**TOWNSHIP OF ABINGTON**

**(2) CODE ENFORCEMENT AND LAND DEVELOPMENT COMMITTEE**

**March 2, 2015**

**Re: Staff Review Comment on Application LD-15-02 for the property Located at  
720 Rhoads Ave., Rydal, Pa. 19046.**

**SITE PLAN**  
 PRELIMINARY/FINAL  
 SUBDIVISION/  
 LAND DEVELOPMENT PLAN  
 OF  
**720 RHOADS AVENUE**  
 IN THE  
 ABINGTON TOWNSHIP  
 MONTGOMERY COUNTY  
 PENNSYLVANIA  
 SCALE: 1" = 50' DATE: JANUARY 14, 2015 SHEET: 2 OF 11

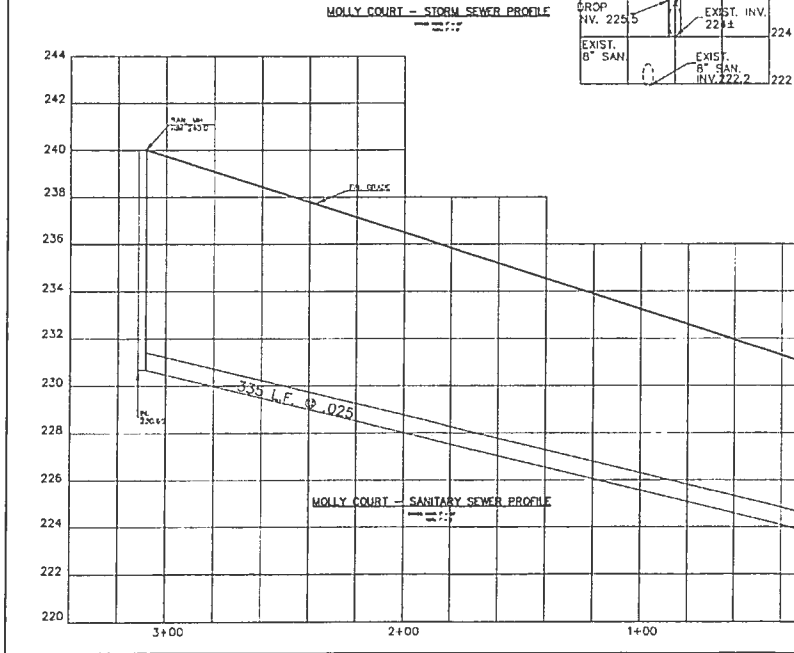
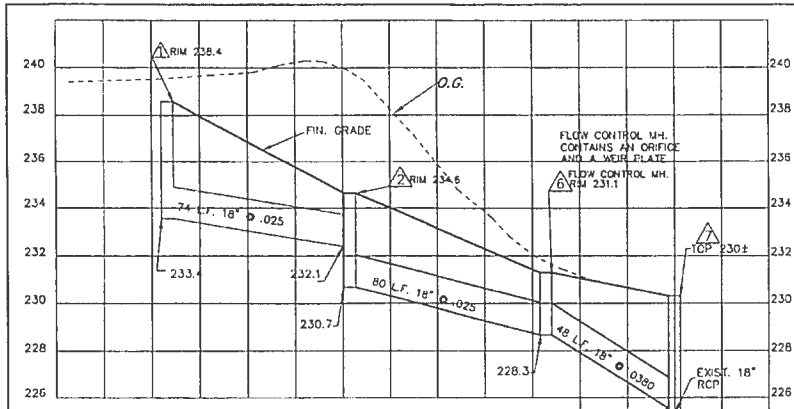
11. The legend indicates a circle with an "S" as an "existing storm manhole", but the plans have that same symbol on the sanitary manholes. This will cause confusion and is required to be corrected.

23. The plan plots the location of pervious paving to be included in the driveways of all eight of the proposed new homes. Has this square footage been included into the impervious coverage calculations? The new storm water ordinance requires this square footage to be included.

24. Several of trees proposed to remain on the plan have construction within the limits of their drip edge. Standard preservation practices prohibit and disturbance with the limits of the drip edge. Please review the structure placement on Lot #5 and Lot #6. Review the on-site storm water management system on Lot #4, Lot #5, Lot #7 and Lot #8.

**STORM / SANITARY  
 PROFILES & DETAILS**  
 PRELIMINARY/FINAL  
 SUBDIVISION/  
 LAND DEVELOPMENT PLAN  
 OF  
**720 RHODS AVENUE**  
 SPHARE  
 ARBINGTON TOWNSHIP  
 MONTGOMERY COUNTY  
 PENNSYLVANIA  
 SCALE: AS NOTED DATE: JANUARY 14, 2015 SHEET: 4 OF 11

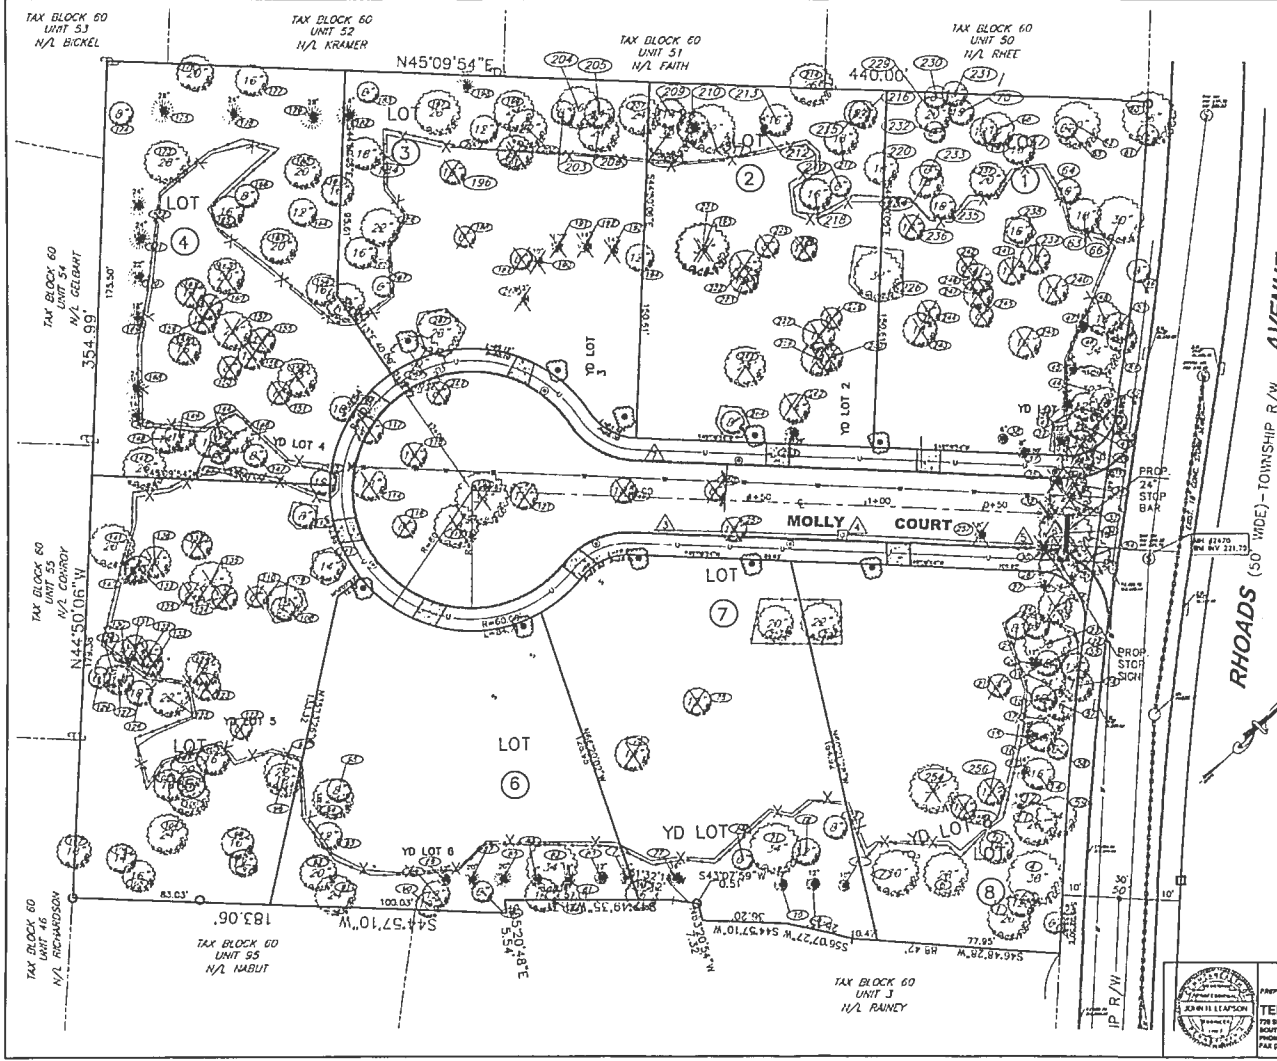
10. The plans need to show a new manhole on Rhoads Road where the new storm water line will be connected to the existing storm sewer. The plan indicates a "Flow Control Manhole" {FCM} for the storm sewer. Detail on this manhole is required to be added to the plan. Also, the plan indicates the FLM as structure #3, a regular manhole as #7 and there is no #8, but there is a #9. We think they are mislabeled. Please review and make the necessary corrections.

21. The plan plots the width of the roadway at 30 feet on sheet #1 and at 47 feet on sheet #4, #5, #9 and #10. Please revise the scale of those plans
22. This project will require seven (7) additional EDU's. They are available, and an ACT 537 Exemption Application has been submitted to DEP for approval. The application was reviewed and approved for sign-off by the Director of Waste Water Treatment Facility.
